**Flow Control Division**

20-Feb-2019

Subject: Spring Deflection Causing Potential Hang-Up of the Flapper (Disc), Worcester Series 44 Swing Check Valve

Picture of Adverse Condition

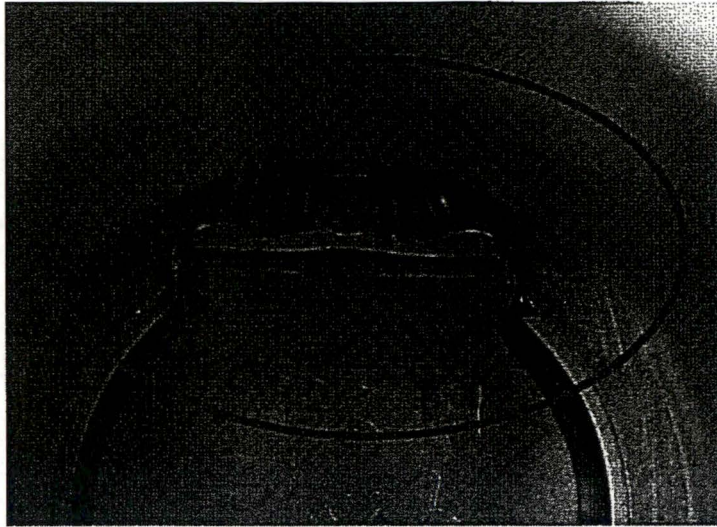
Evaluation: Shop inspections of the returned valves confirmed the potential for the spring legs to rotate outwards and potentially wedge between the flapper and seat retainer. Of the five valves evaluated, two of the valves had the spring legs rotate outward and after repeated cycles got caught between the flapper and disc; on one of the instances the spring legs prevented full closure of the flapper.

The evaluation determined the cause is an inadequate spring design which allows the spring to deflect and permit the legs to move outward.

- Owner's may remove the springs. The valves will check-off and seal under low pressure conditions without the assistance of the spring; this was demonstrated in shop tests using tap water pressure (approximately 60 psig) and will initiate closure when full open without the assistance of the spring.
- Flowserve is evaluating alternate spring designs along with the possibility of adding guides to prevent the undesired spring movement. Any new design will be proof tested.

General Assembly Views

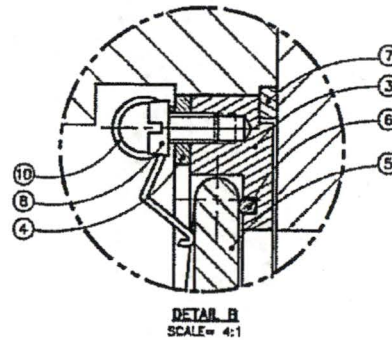
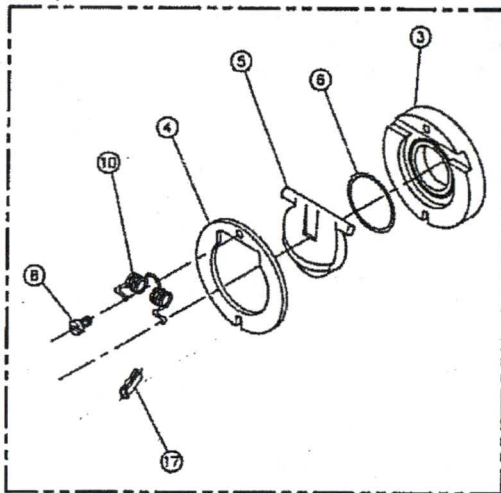
Description: GE BWXT, acting on behalf of Ontario Power sent five valves back to the Flowserve facility for evaluation of the spring which could spread apart when the flapper rotates open and wedge between the valve body and flapper, creating the potential for the valve flapper to stick open.
